ITEM #1: For the **ARCHITECTURAL COMMISSION** on **MONDAY, November 10th @ 7:00 P.M.**

REQUEST: Consideration of the final site plan, landscaping, lighting, signage and elevation plans as part of an application by Harbor Retirement Associates for an amendment to the previously approved Special Use Permit and Planned Unit Development known as the Fairfield Village Planned Unit Development and within the R-2 PUD District to provide for a senior living center with Memory Care and Assisted Living Facilities for the property at 1190 Old McHenry Road, submitted by Harbor Retirement Associates.

Harbor Chase

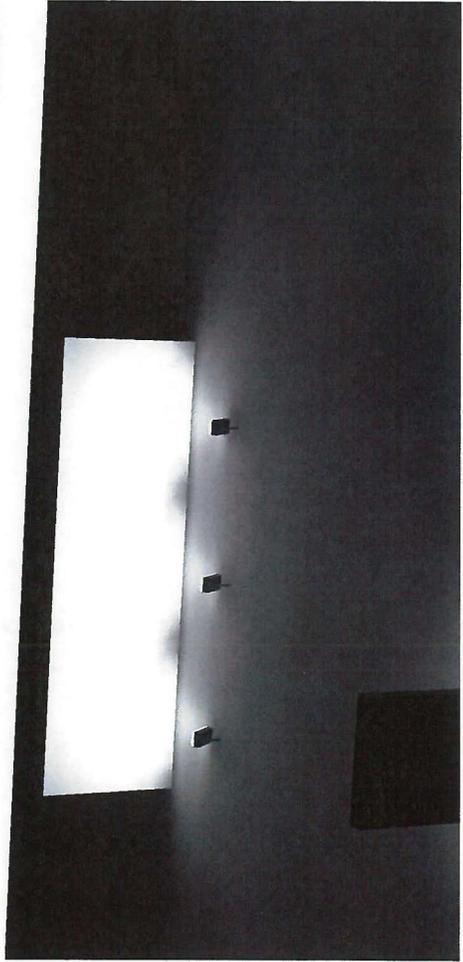
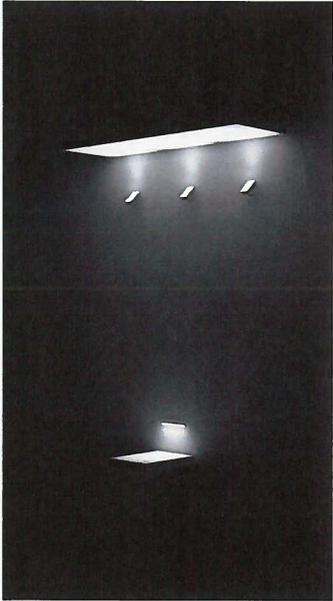
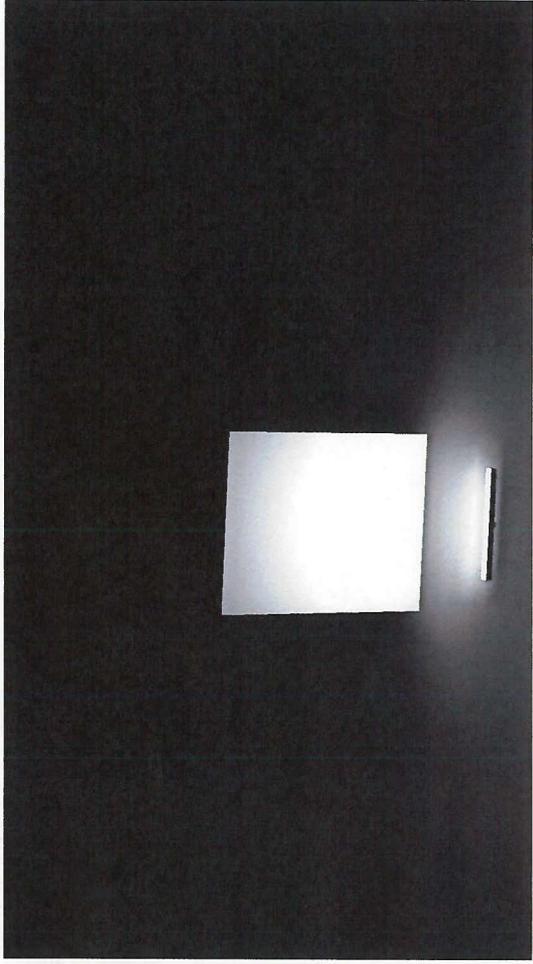
The AC also considered final signage plans at the meeting of October 20th. The AC found the signage to be acceptable but had questions regarding the illumination source and the screening there of for the signage. A motion was made as follows;

A motion was made by Commissioner Tapas, seconded by Commissioner Styer, to accept the signage as presented subject to detailed plans for lighting (cut sheets) and landscaping of lighting being submitted for the monument sign and secondary (directional) signage for further AC review. On a voice vote; all aye.

Petitioner has submitted fixture types and detailed plan the screening of such fixtures. These are attached and were submitted to the AC electronically.

Details on signage illumination & fixture screening as requested by the Commission have also been received.
